# Access Compliance Report

## Public Rights-of-Way

### (Curb Ramps)

Intersection ID: 21560	Main Street: RITTENHOUSE_CR	Cross Street: SARDIS_RD_NORTH	Location: SW
ADA ID: B20A897F7293	Ramp Type: PerpDiag	Initial Pass/Fail: Fail	Overall Compliance: No
			Severity Score: 41.25

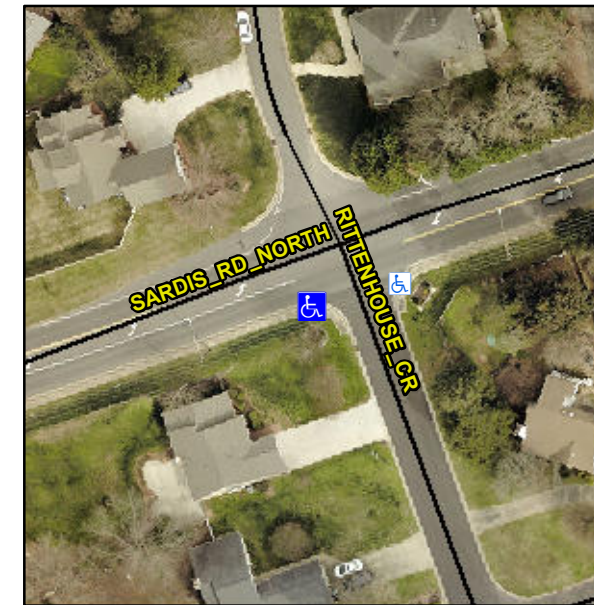
**Not Found, R304.2.2, R304.5.3, R302.7**

Compliance	Description	Data	Compliance	Description	Data
N/A	Ramp Length (in)	48.0	No	Ramp Slope (%)	14.9
Yes	Ramp Width (in)	48.0	No	Ramp XSlope (%)	2.2
N/A	Flare Type LT	N/A	N/A	Flare Type RT	N/A
N/A	Flare Slope LT (%)	N/A	N/A	Flare Slope RT (%)	N/A
N/A	Flare Traversable LT?	N/A	N/A	Flare Traversable RT?	N/A
N/A	Landing Length (in)	N/A	N/A	DWS Provided?	N/A
N/A	Landing Width (in)	N/A	N/A	DWS Contrast?	N/A
N/A	Landing Slope (%)	N/A	N/A	DWS Length (in)	N/A
N/A	Landing X Slope (%)	N/A	N/A	DWS Full Width?	N/A
N/A	Landing Curb? (Y/N)	N/A	N/A	DWS Offset (in)	N/A
N/A	Shared Landing?	N/A			
N/A	Gutter Ponding?	N/A	N/A	Gutter Slope (%)	N/A
N/A	Gutter Lip Ht (in)	N/A	N/A	Gutter X Slope (%)	N/A
N/A	Painted X Walk1?	No	N/A	Painted X Walk2?	No
	X Walk 1 Direction	To E		X Walk 2 Direction	To N
N/A	X Walk 1 Width (in)	N/A	N/A	X Walk 2 Width (in)	N/A
	X Walk 1 Slope (%)	2.7		X Walk 2 Slope (%)	6.3
	X Walk 1 X Slope (%)	5.1		X Walk 2 X Slope (%)	1.6

N/A	Ramp inside XWalk1?	N/A	N/A	Ramp inside XWalk2?	N/A
	Road Slope (%)	3.1	N/A	Clear Space?	N/A
	Road X Slope (%)	3.9	N/A	Clear Space to XWalk (in)	N/A
N/A	Any Obstructions?	N/A	N/A	Storm Grate/Utility Hazard?	N/A
	Obstruction Type			Storm Grate/Utility Type	
		N/A			N/A
		No		Surface Condition? (G/P)	Poor

**Remove & Replace Curb Ramp With Two New Directional Ramps or Equivalent.**
